**FINAL
MY2 (2023) MONITORING REPORT**

PHANTOM MILL

Response to DMS Comments – MY 2 (2023) Report

Phantom Mill Mitigation Site – Alamance County

**CURRENT
CONDITIONS
PLAN VIEW**

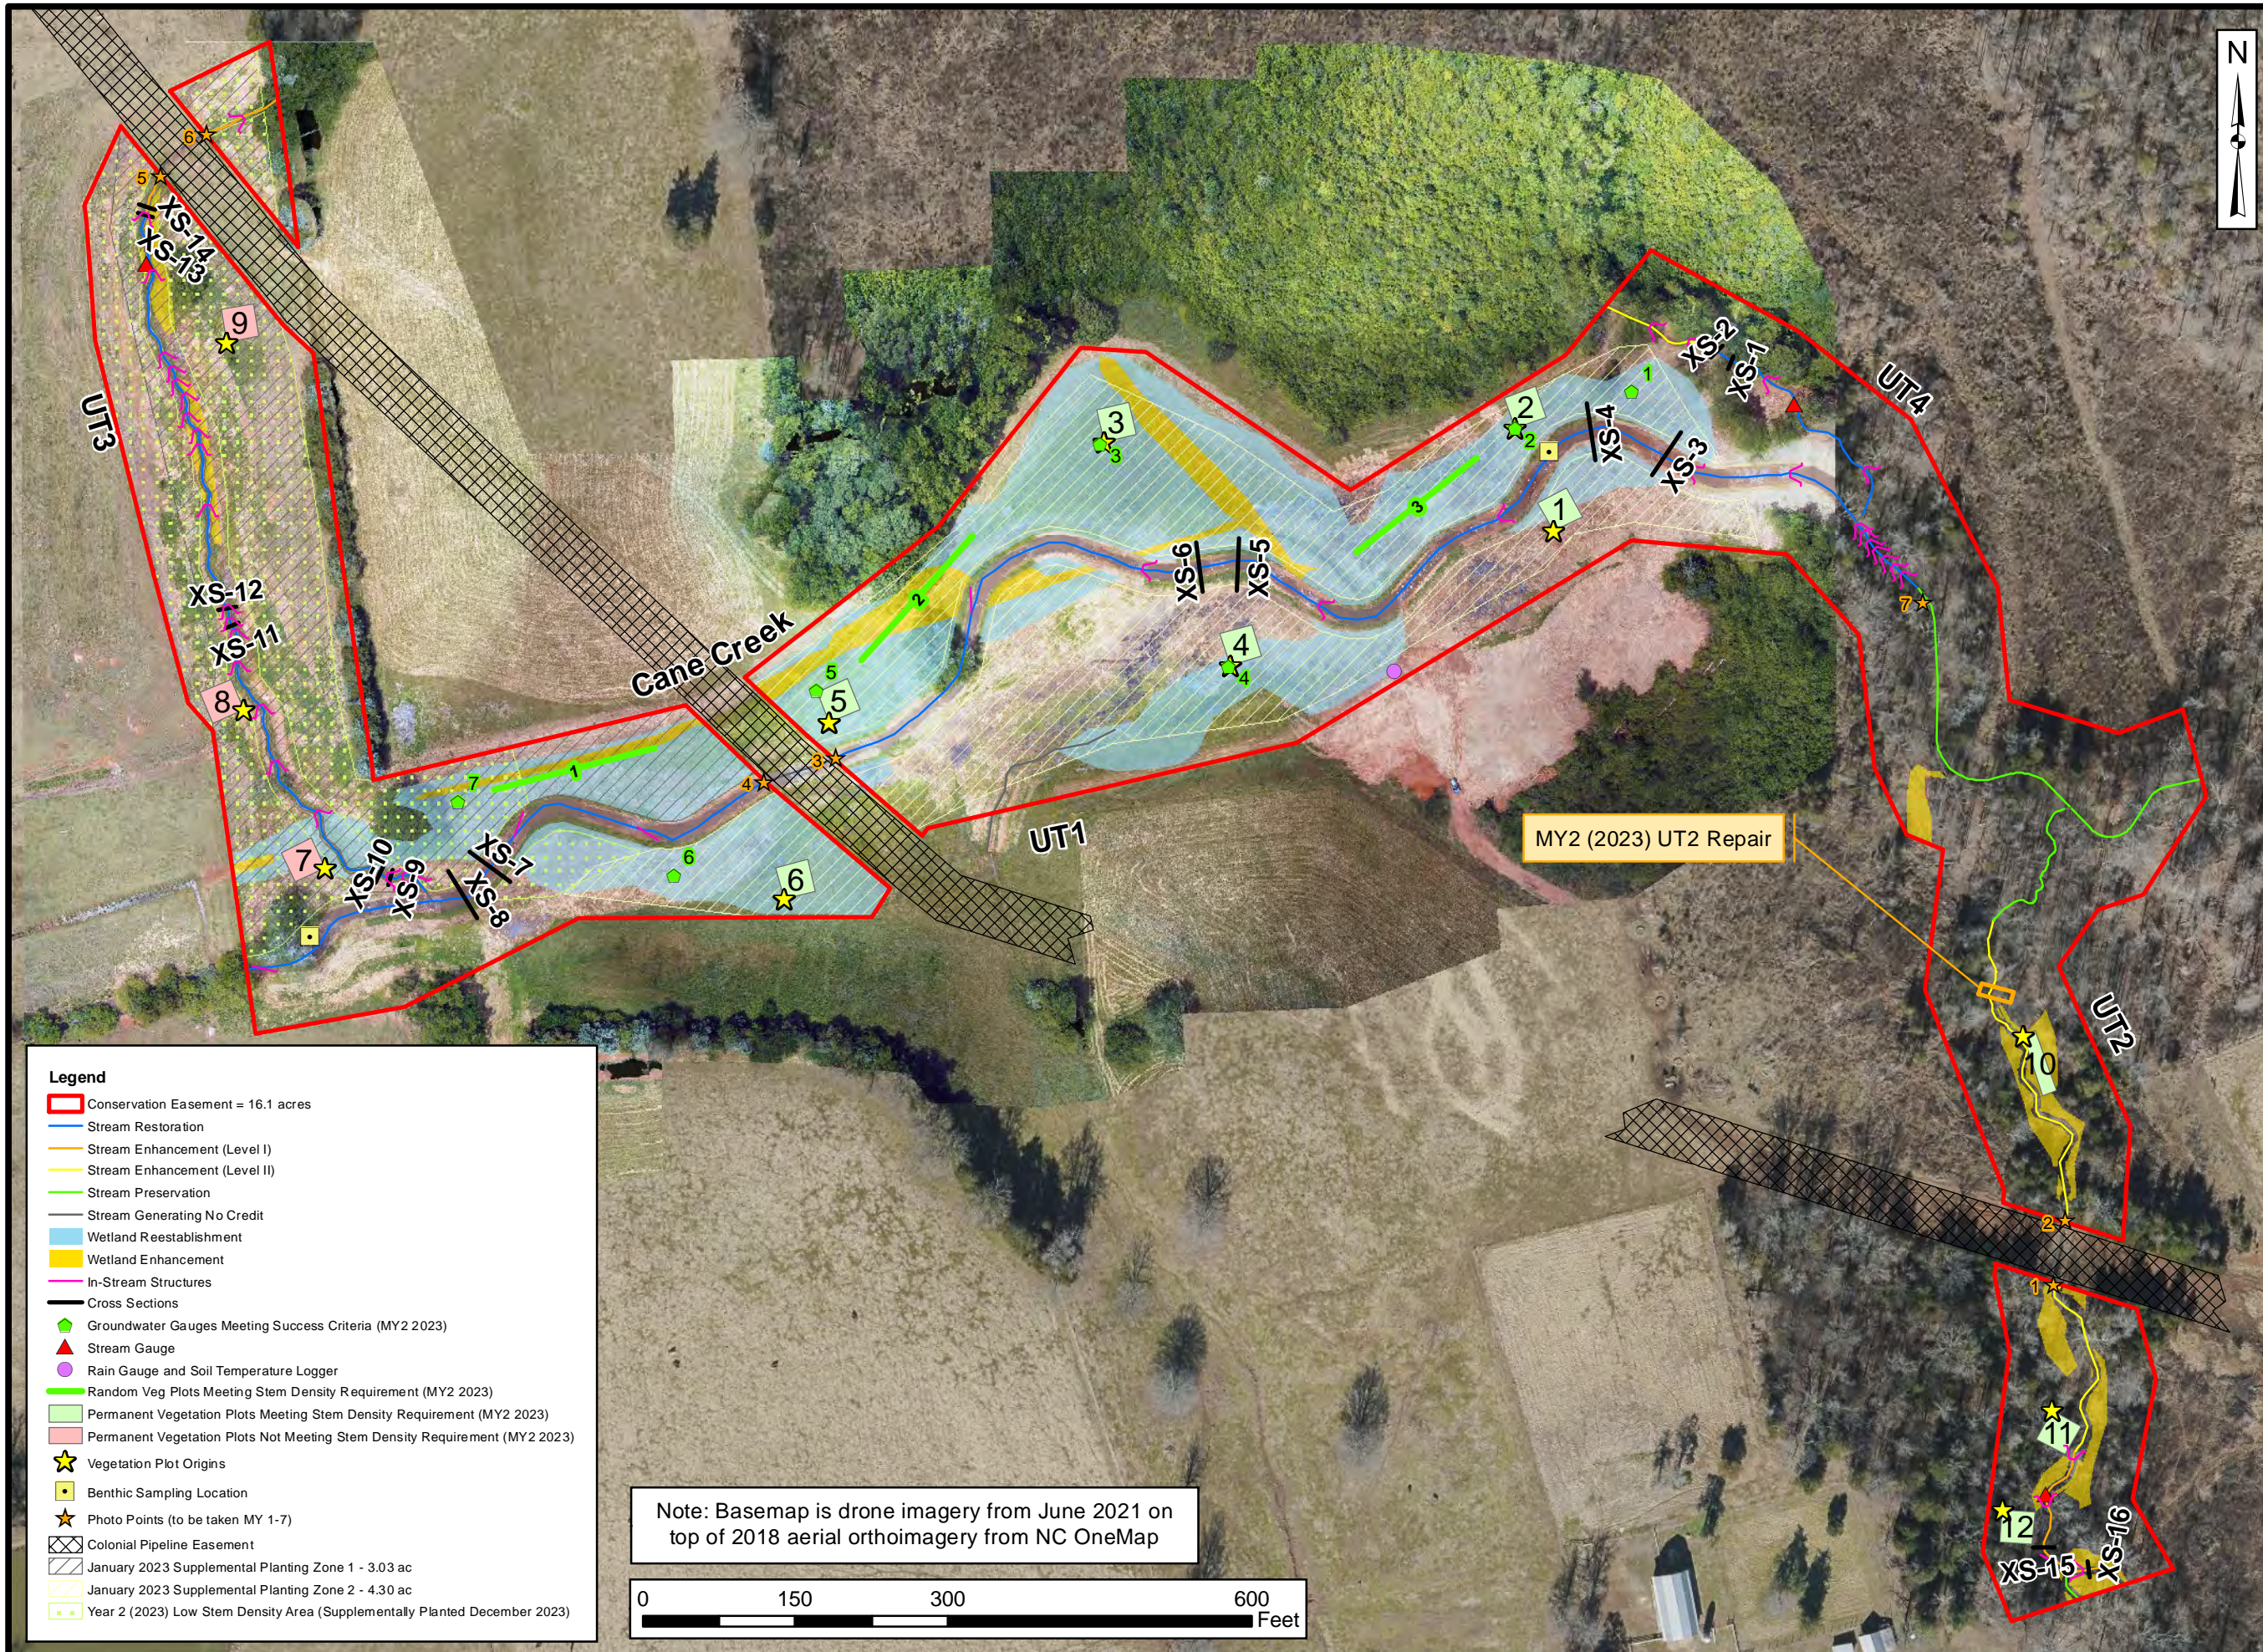
1. Appendix A, Table 5 (visual assessment): Does RS believe 7.333 acres of the planted area are still low in stem density? Please review and update. If applicable, please provide a shapefile for any areas that are still low in stem density.

Response: Based on MY2 (2023) data, RS does believe the upland areas of UT3 should be considered a “Low Stem Density Area.” We have also included a portion of Cane Creek floodplain where herbaceous overtopping was observed during the dormant season of 2023/2024. Table 5 and the CCPV were updated, and a 2023 “Low Stem Density Area” shapefile was added to the digital submittal. The “Low Stem Density Area” is 2.746 Acres, down from the 7.333 acres stated in the MY1 (2022) Monitoring Report.

Given the MY 2 (2023) vegetation survey data associated with UT3 (vegetation plots 7, 8, and 9) RS was able to plant ~245, 1 and 3-gallon containerized trees within the Low Stem Density Area of UT3. Species included River birch, Ironwood, Persimmon, Tulip poplar, Black gum, Sycamore, White oak, Water oak, Willow oak, and Red oak. The planting effort was completed on December 22, 2023, and no stems were planted within the vegetation plots. RS will conduct random vegetation transects along UT3 in the Spring of 2024 to better understand the extent of the Low Stem Density Area. A brief narrative, including a list of the planted stems, was added to the vegetation summary in Section 2.1 of the report.

Photo 20: UT2 Repair

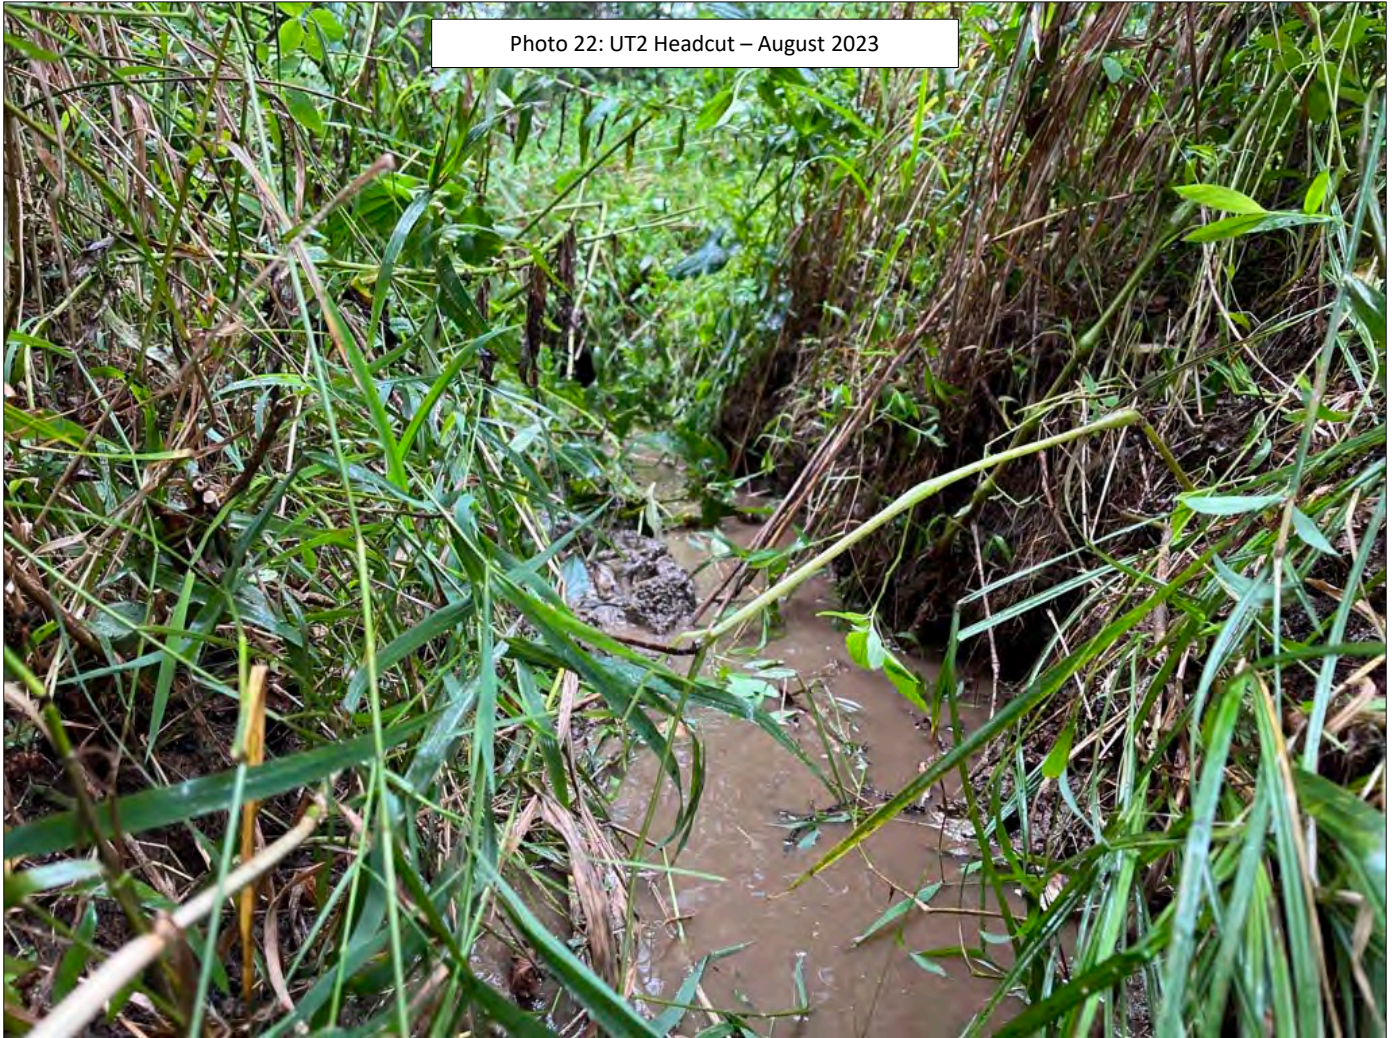
8. Appendix F, Photo Log: Please include photos of the piping/headcut area on UT2 before maintenance was completed.
Response: Unfortunately, RS does not have any high-quality photos of the piping/headcut area on UT2 given the dense herbaceous vegetation. Two photos taken August 3rd were added to the 2023(MY2) Photo Log.

Phantom Mill UT2 Stream Flow Gauge MY 2 (2023 Data)

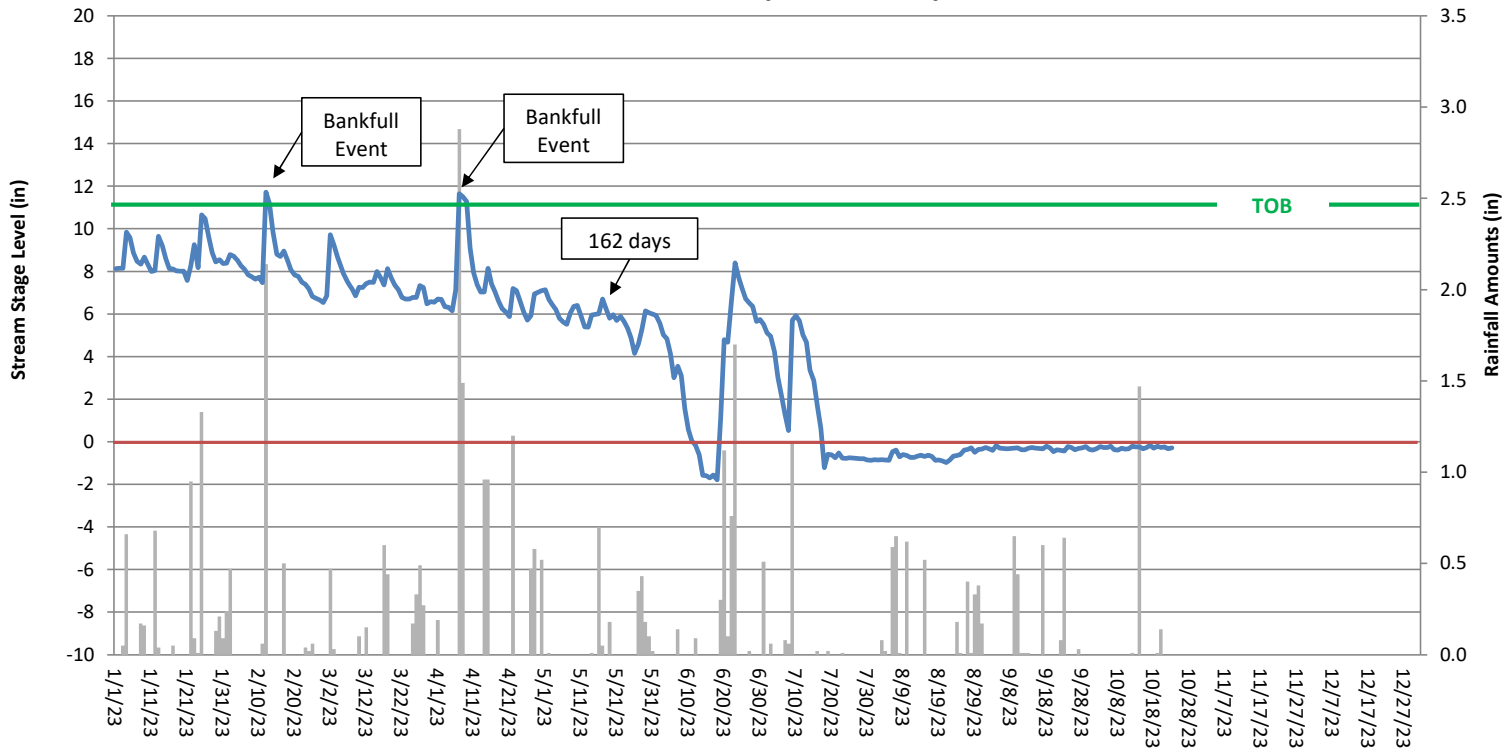
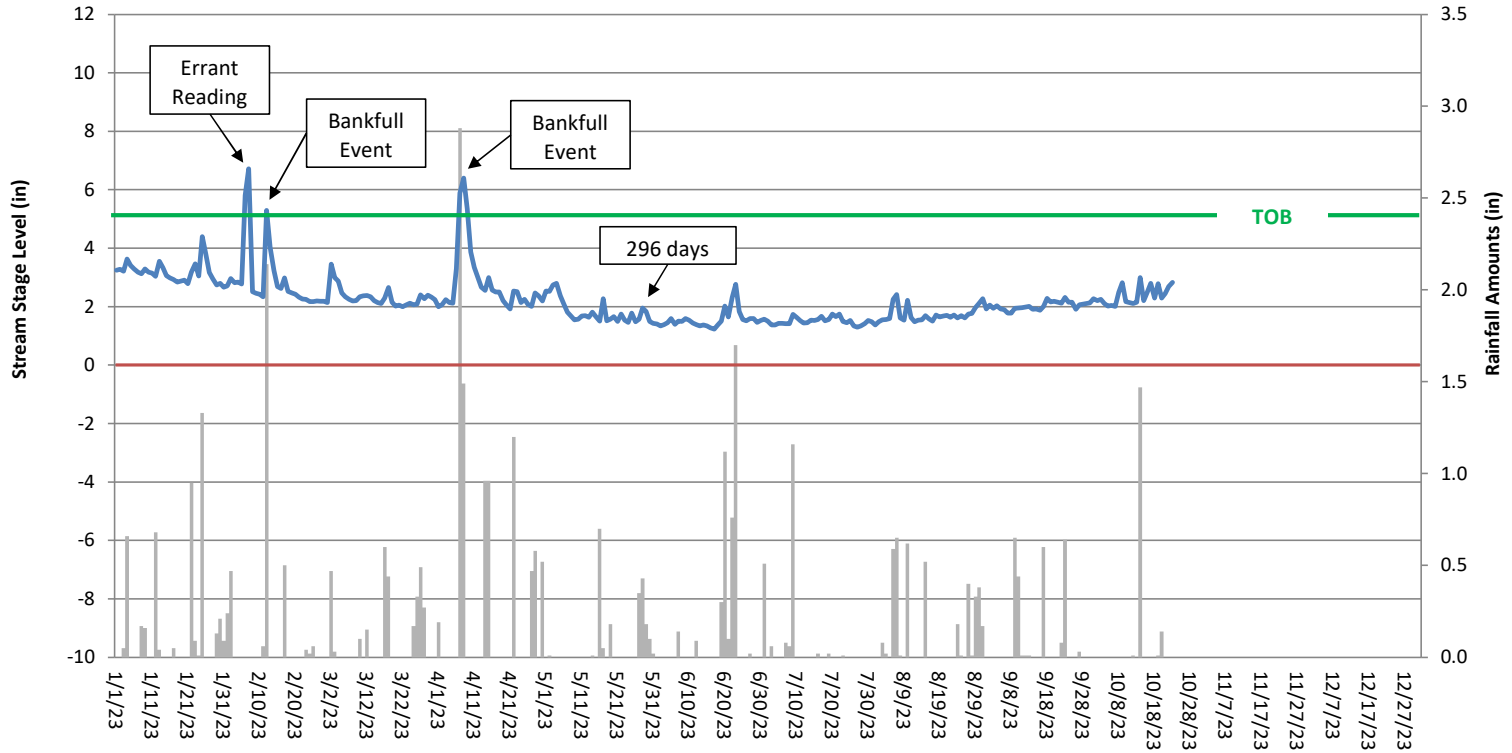
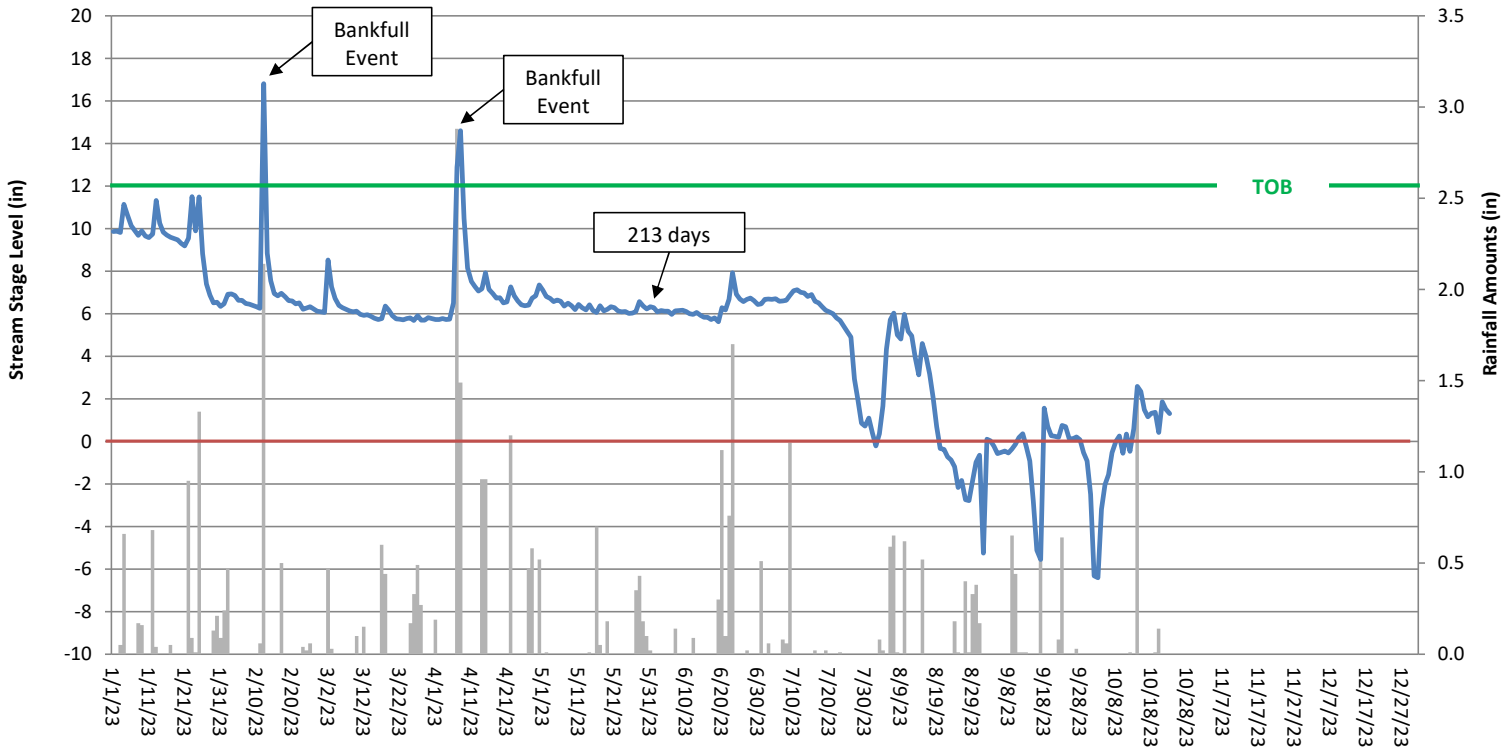
5. Appendix D, Surface Water Gauge Graphs: For clarity, please include a line on the graphs where bankfull is located.
Response: Top of bank lines have been added to all surface water gauge graphs in Appendix D.

Figure D1: Phantom Mill 30-70 Percentile Graph for Rainfall

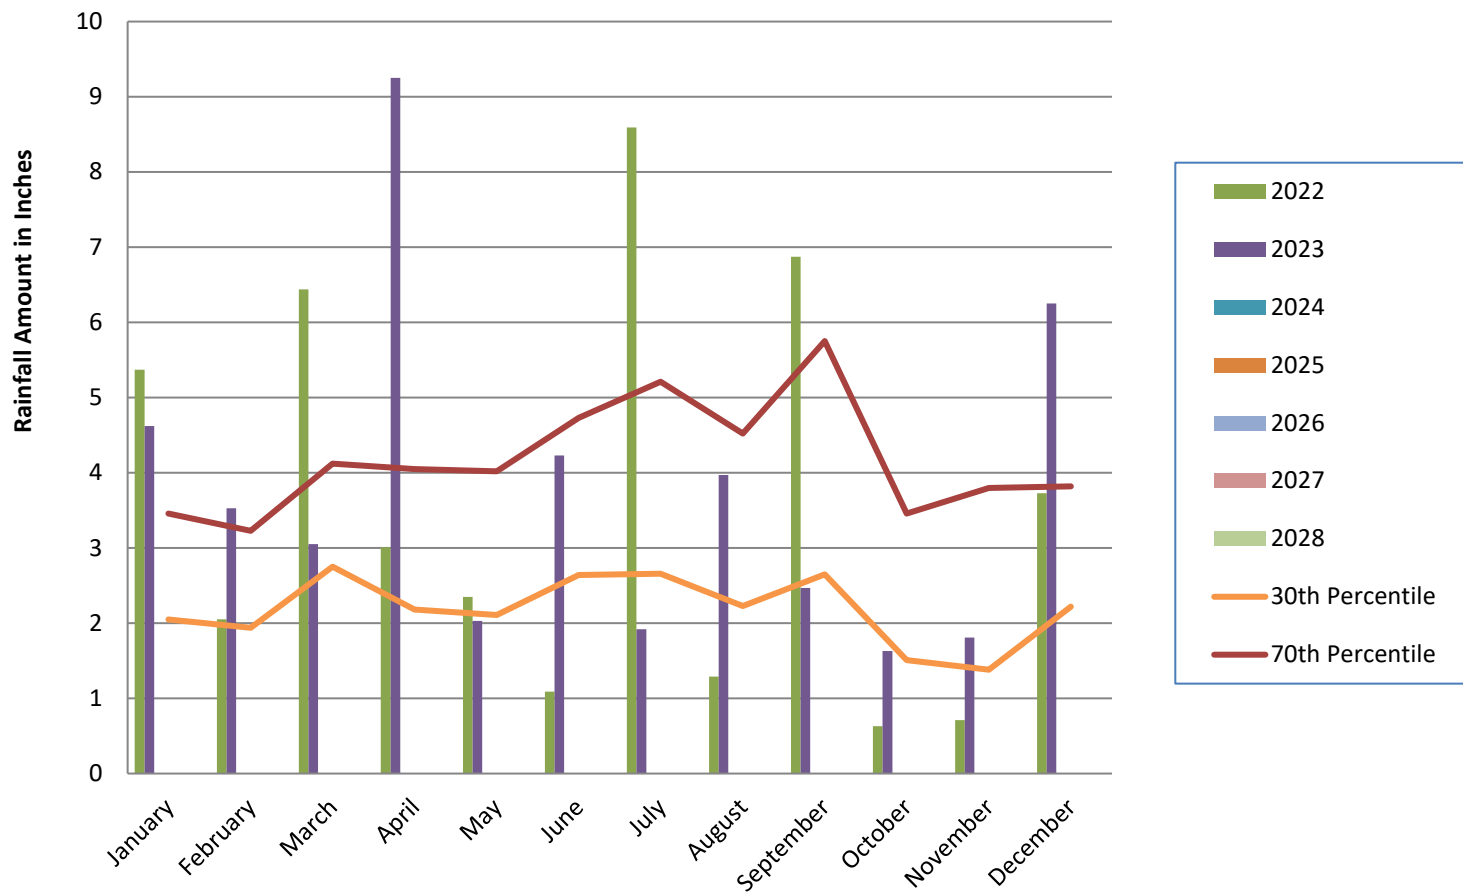
6. Appendix D, Figure D1 Rainfall: Please update rainfall data through November and December.
Response: Appendix D, Figure D1 has been updated through November and December.
